10/634,918

Office Action Summary

DETAILED ACTION

Fig.1

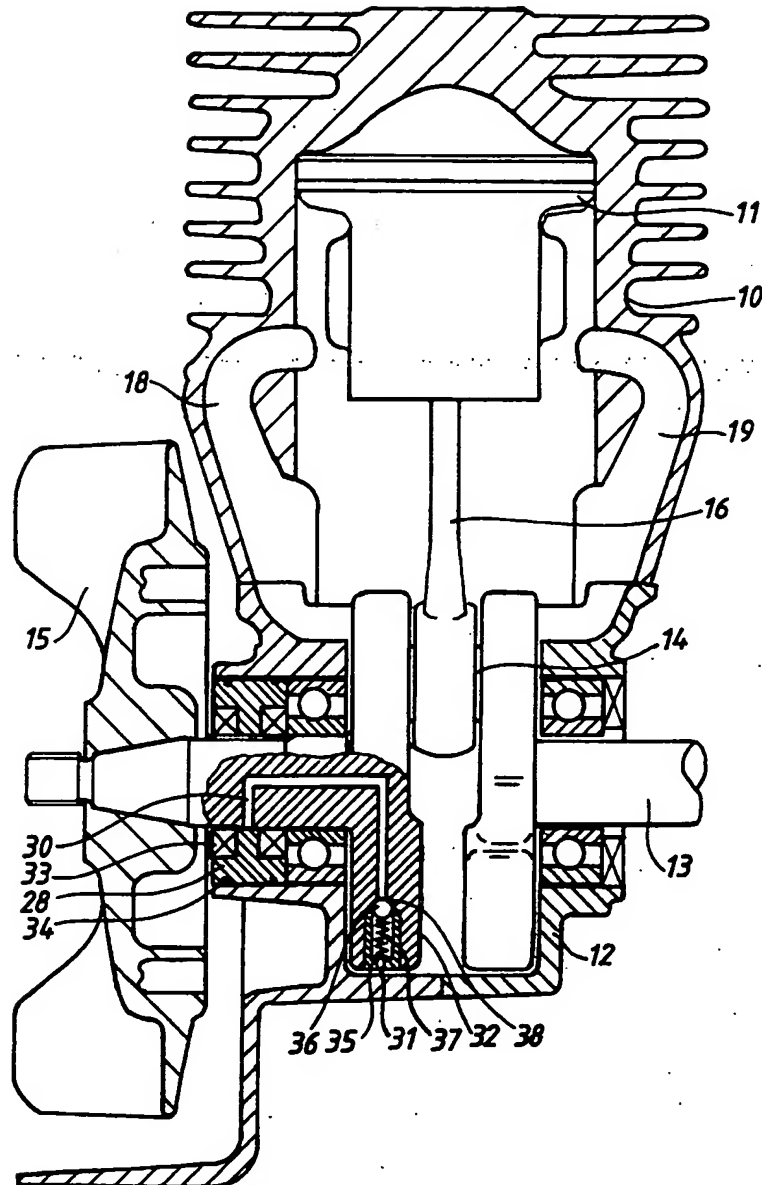
plane, which is at a right angle to a crankshaft and contains an axis of the cylinder, wherein the front and rear portions are attached to each other by fasteners 11, wherein a crankcase scavenging passage is formed inside a wall in each of the front and rear crankcase portions symmetrically with respect to said crankcase separating plane, the front and rear portion scavenging passages being formed above the crankshaft bearing part, wherein the scavenging passage has a top opening above a cylinder mounting surface and an outlet at the side of the crankcase with a microscopic gap between the opening and the end surface of the crank webs 15A, wherein each of the front and rear portions includes a scavenging passage which provides fluid communication between the scavenging passage of the cylinder and a crank chamber of the crankcase so as to allow a fuel-air mixture to flow from the crank chamber to the scavenging ports, wherein the cylinder is attached by fasteners to a mounting surface on the crankcase (see column 2, lines 67-69), and wherein the scavenging passages of each of the cylinder and the crankcase are arranged symmetrically along a front to rear plane of the engine. Tenney shows everything except the crankshaft bearing part in each front and rear portion being formed within a diameter of the cylinder. Doragrip teaches that it is old in the art to form the crankshaft bearing parts within a diameter of the cylinder (see Figure 1 on next page).

It would have been obvious to one having ordinary skill in the art to modify Tenney by locating the bearings such that they are within the diameter of the cylinder, since this is conventional.
